**DATE:** September 3, 2021  
**TO:** Prospective Bidders  
**FROM:** Hugo Garcia, Project Manager  
**SUBJECT:** Addendum No. 10  
RFP, Real Journey Academy – Fontana Charter School

This Addendum modifies and forms a part of the Request for Proposal (RFP) issued July 23, 2021 for the above-referenced project. Bidders shall acknowledge receipt of this Addendum in the cover letter.

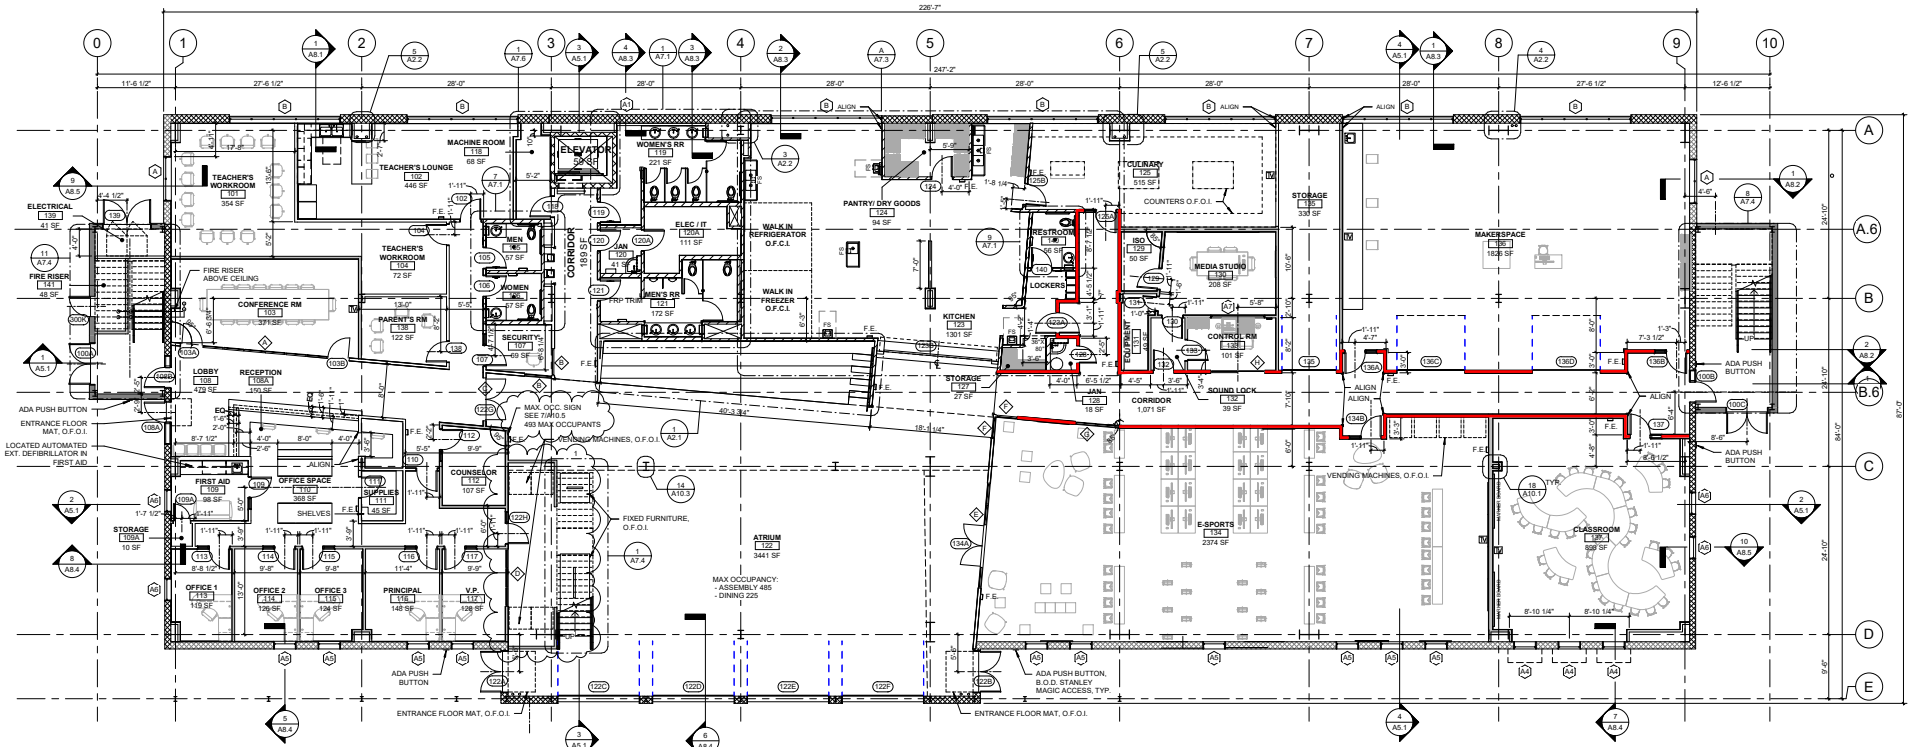
Question: The plans & specs are calling for Rockfon Ceiling Grid, which they do not make, Chicago Metallic is used. The Rockfon ceiling tile calls for "Standard School", can you please specify what that is.

Response: Yes, Chicago Metallic was acquired by Rockfon for grids.

Grids: 1200 15/16", LS square tegular, Seismic, with required wall angles.

Ceiling tiles for instructional spaces are "Education Standard".

<https://www.rockfon.com/products/tiles-and-panels/modular-ceilings/basic-white/rockfon-education-standard/?selectedCat=document%20list>. Square Tegular

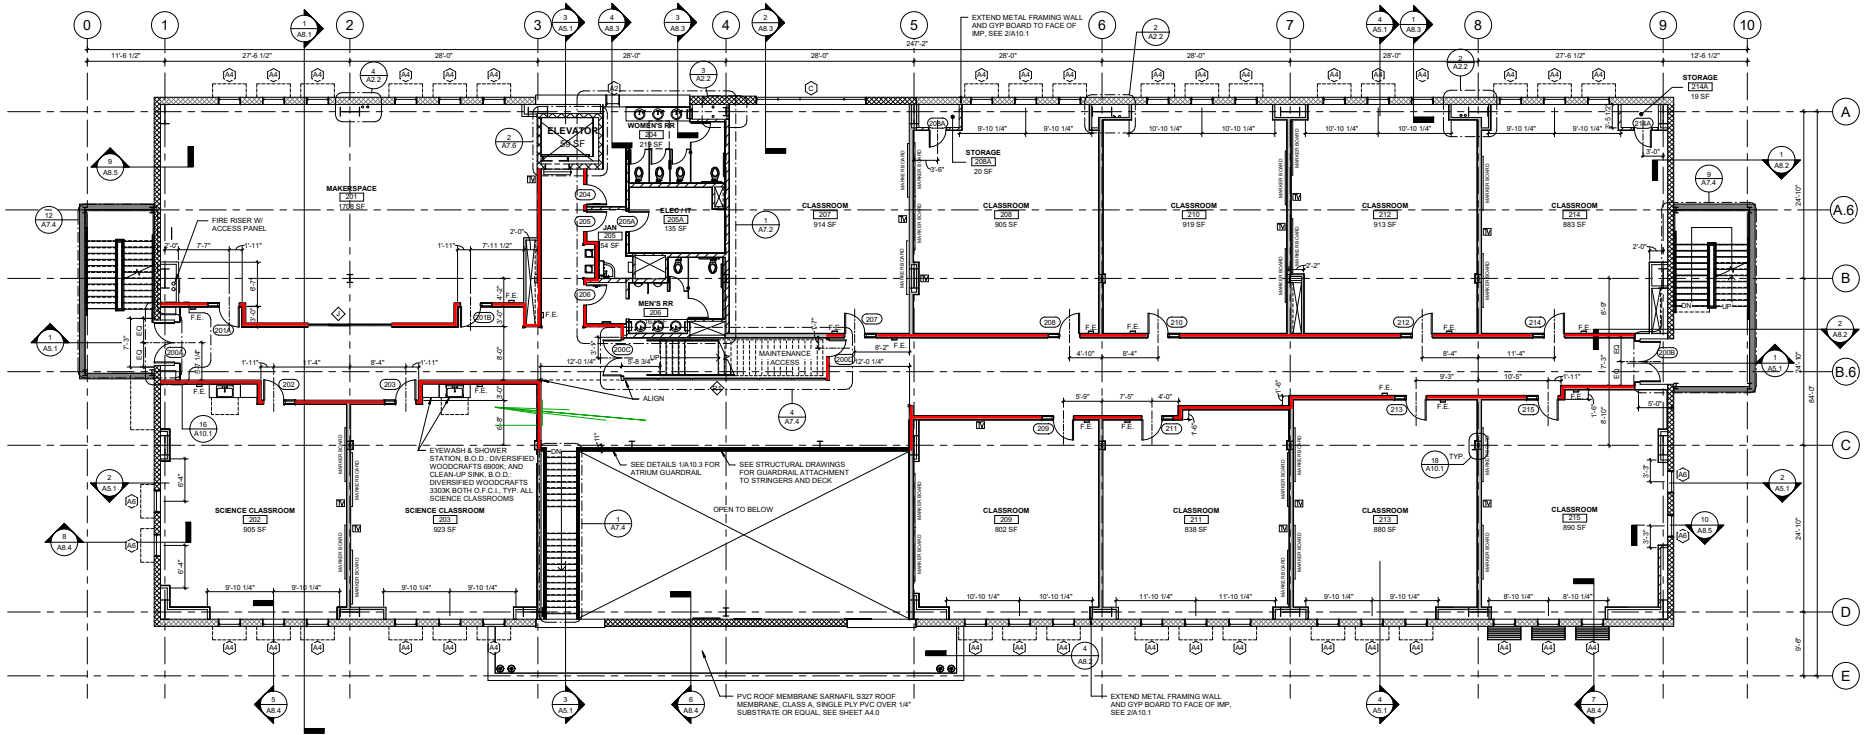
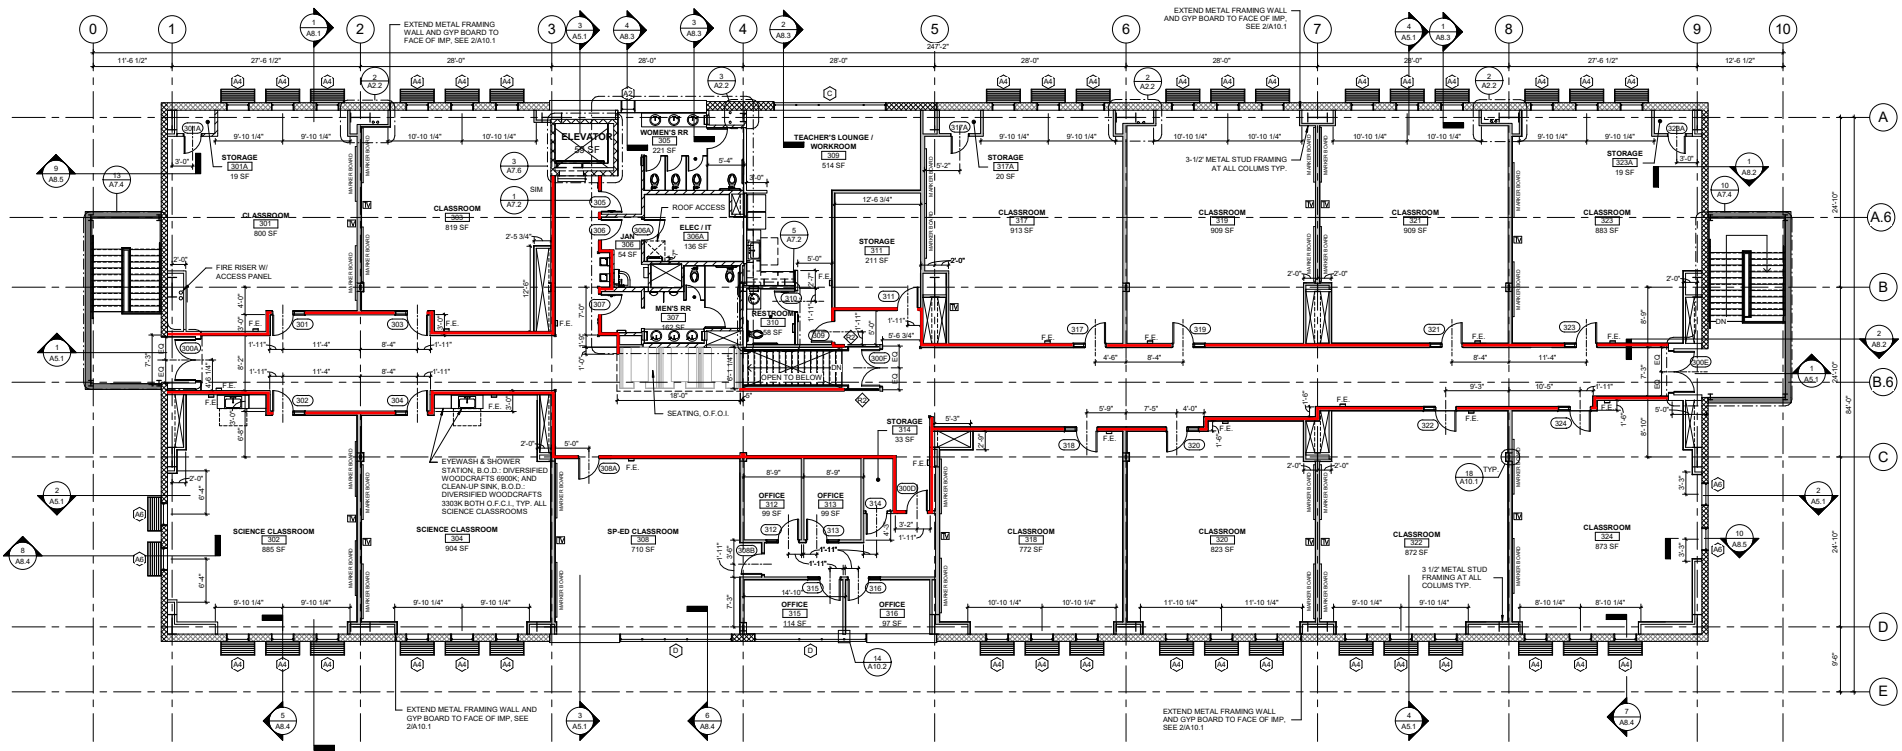
Question: Please advise as to which areas are to have high impact drywall. The specs say all corridor walls, can you please advise which walls and what height would require high impact drywall.

Response: **See attached diagram RFI#57-ARGB.pdf for locations.** Provide abuse resistive gypsum board (ARGB) from F.F. to 4'-0" A.F.F. Provide architectural reveal bead between ARGB and regular gypsum board: 5/8" deep and 1/2" wide.

— WALLS TO RECIEVE ABUSE RESISTANT GYP. BD.

— WALLS TO RECIEVE ABUSE RESISTANT GYP. BD.

**13** **BUILDING LOGO SIGNAGE**  
 1/4" = 1'-0"

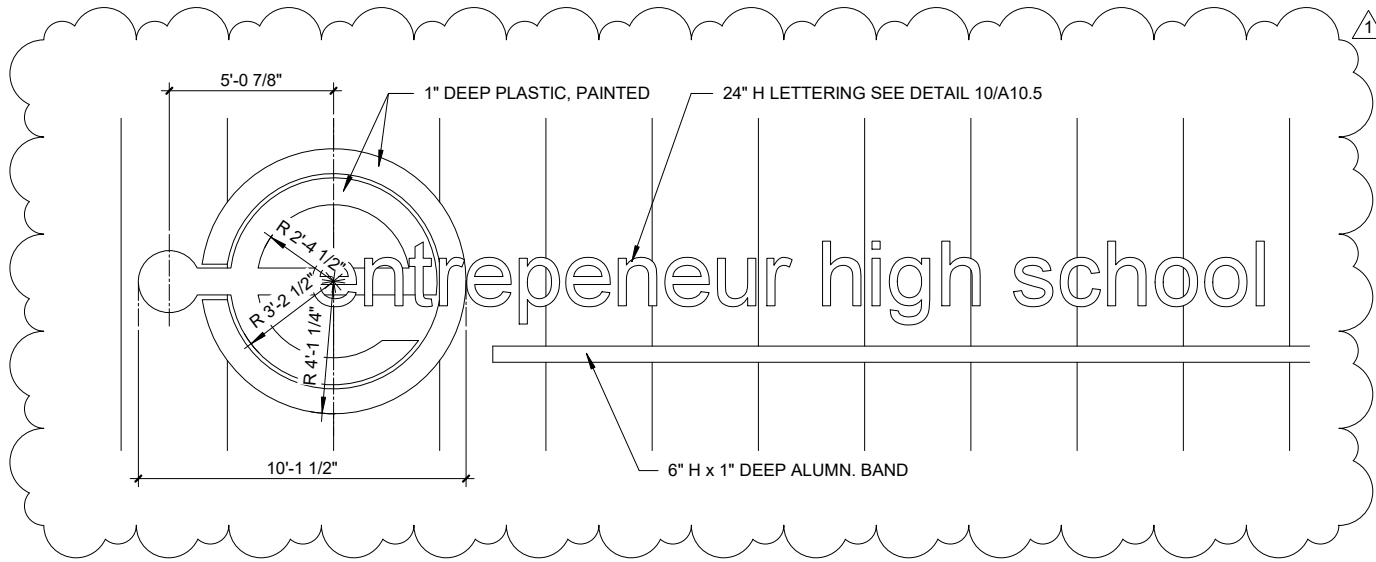
Question: There are no specs for the Building Logo Signage on sheet A10.5, detail 13. Please provide more information on this.

Response: **See attached detail RFI58-13/ A10.5.pdf**

NOTE: VERIFY FONT AND TEXT PRIOR TO CONSTRUCTION.
